# **Report to the Arlington Redevelopment Board**

## **Recommended Traffic Mitigation Symmes Redevelopment**

**Arlington Transportation Advisory Committee**

**11 April 2005**

Fig 6. Operation of the Summer Street Corridor at the AM and PM peak hours (Project Built, 2009, signal at Hospital Rd coordinated with Hemlock, Mill optimized but not coordinated, 10% volume increase, signal at Grove and at Oak Hill, Woodside open one-way)

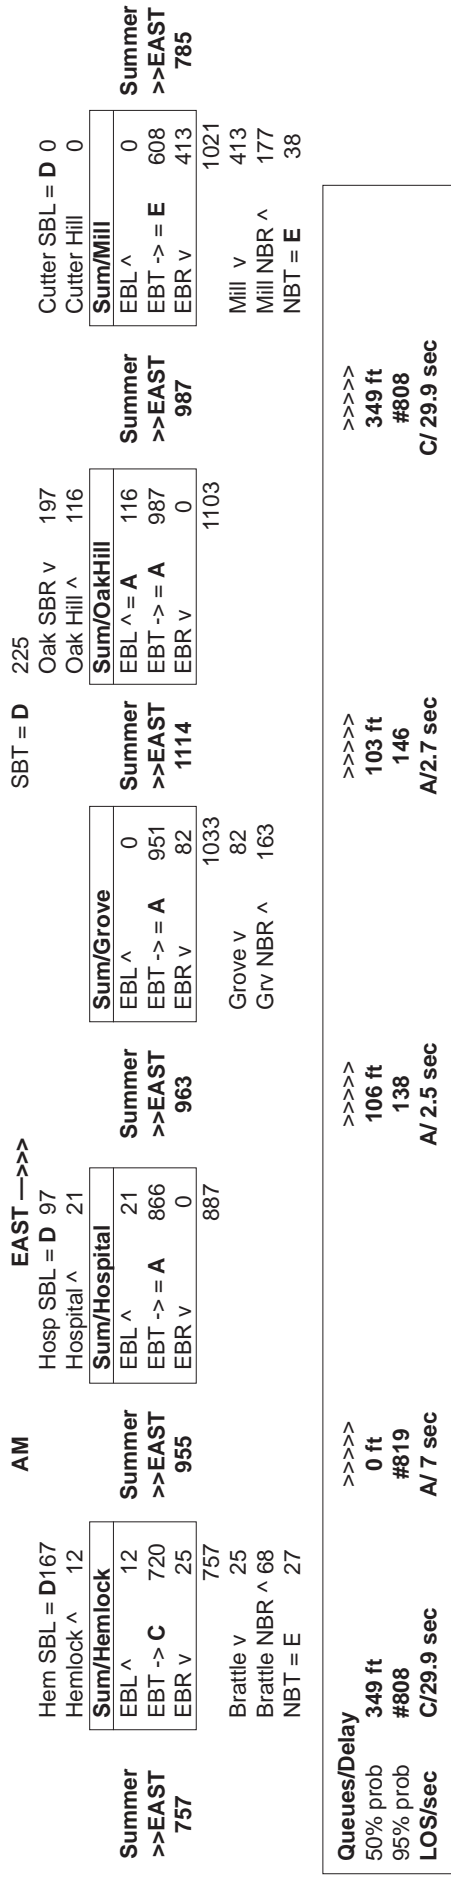
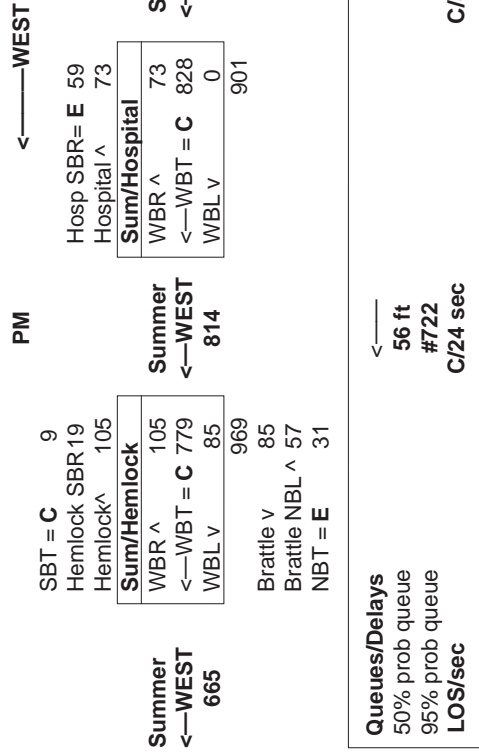
The analyses of the corridor are summarized in Fig 6. Fig 6.1 is eastbound at the AM peak hour and Fig 6.2 is westbound at the PM peak hour.

These analyses indicate that the corridor operates satisfactorily at 10% volume, with signals at Grove and Oak Hill, and Mill/Summer optimized but not coordinated. The intersections in this string operate at LOS C-A-A-A-E from east to west in 6.1, and LOS A-A-C-C from west to east in 6.2 (Mill was not analyzed). The LOS E eastbound for the Mill/Summer/Cutter Hill intersection is the same as the current operation in the morning. The only apparent difficulty is the queue westbound in the PM at Hospital Road backing up to and blocking Grove Street. There is 440 ft between the east edge of Hospital Road and the west edge of Grove Street. The 50% probable westbound queue is 530 ft. This will be discussed in a later section when a right turn pocket westbound into Hospital Road is discussed.

Fig 7 Operation of the Summer Street Corridor Eastbound at the AM peak hour (Project Built, 2009, signals on Summer Street at Mill St, Oak Hill Dr, Grove St, Hospital and Brattle St, Woodside open one-way)

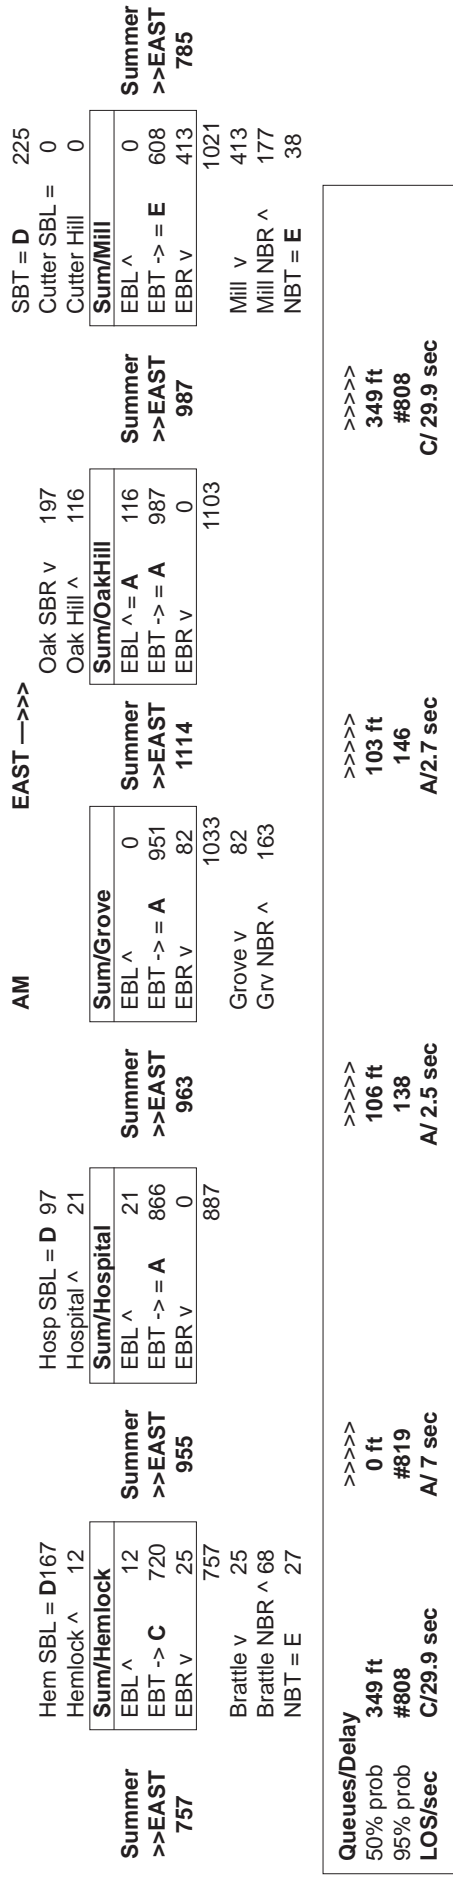
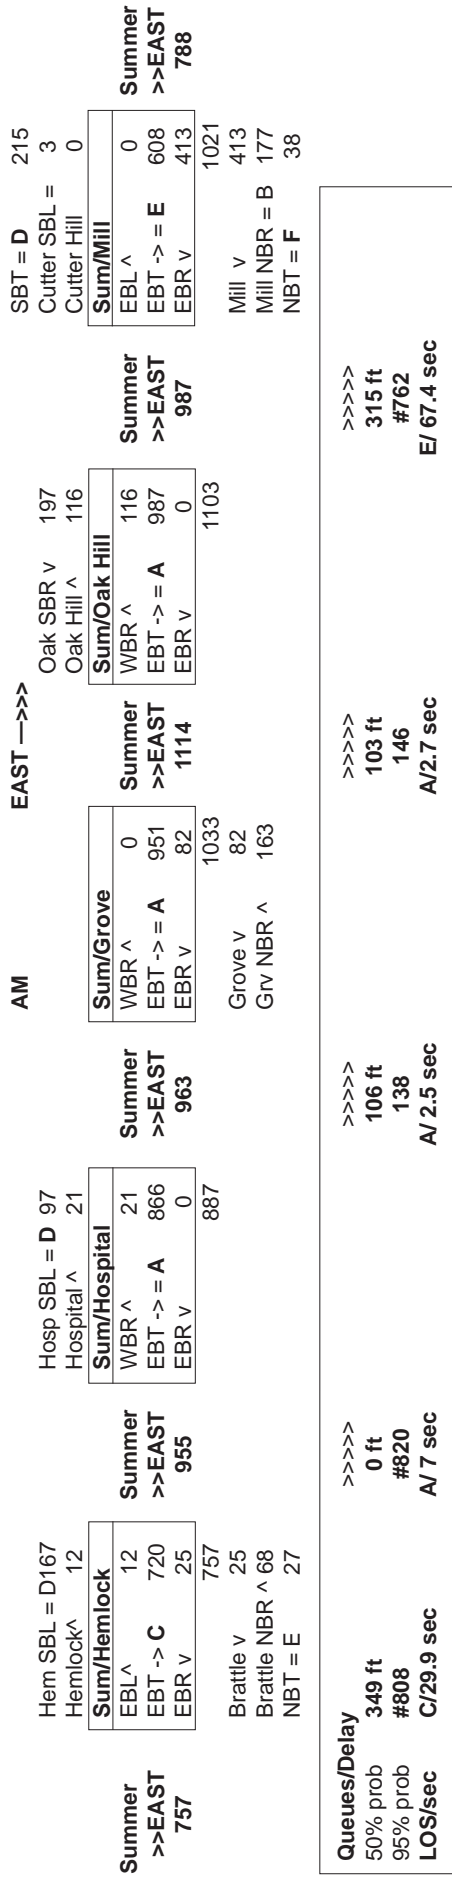
Fig 7 illustrates a sample of the results from analyses of coordination of all signals in the corridor. Fig 7.1 is AM peak hour eastbound without the Mill/Summer intersection added to the coordination, and Fig 7.2 is with it added to the coordination.

Coordinating the Mill/Summer intersection with the other signals makes a little difference to the rest of the corridor, but degrades the performance at Mill/Summer. This coordination does not help and is not recommended.

Fig 8. FST Potential Pedestrian Crossing/Calmng Concept at Summer Street and Oak Hill Drive

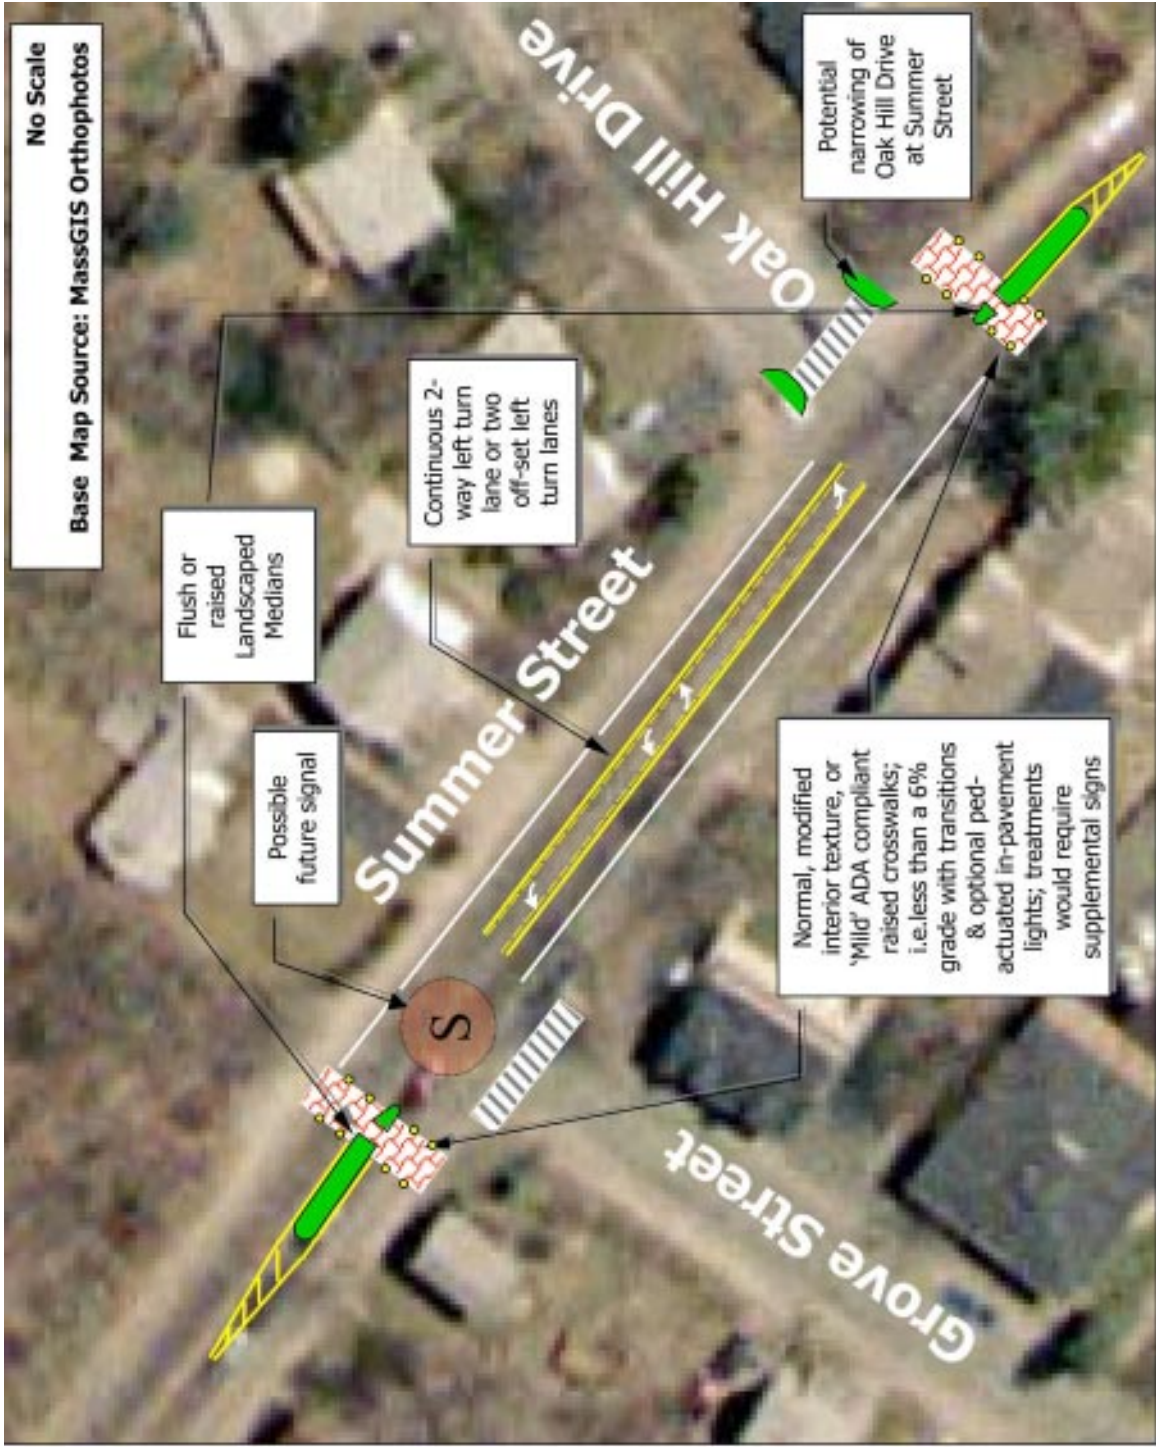
Another option suggested by FST is a set of traffic calming and pedestrian assistance measures to improve safety without a signal. A modification of this suggestion would be traffic islands placed on the eastbound approach to Grove and the westbound approach to Oak Hill. Crosswalks would be installed at the intersection side of each of the islands. In the 150 ft between the intersections, a middle lane would be marked-off that could be used for left turns from either direction. Fig. 8 from FST illustrates this concept.

#### **Recommendation A.3 Adopt a phased approach for the Summer/Grove and Summer/Oak Hill intersections. Phase 1) Traffic calming measures to include refuge islands and crosswalks at Grove and Oak Hill; Phase 2) If needed, signal at Grove Street coordinated with the signals at Summer/Hospital/Brattle.**
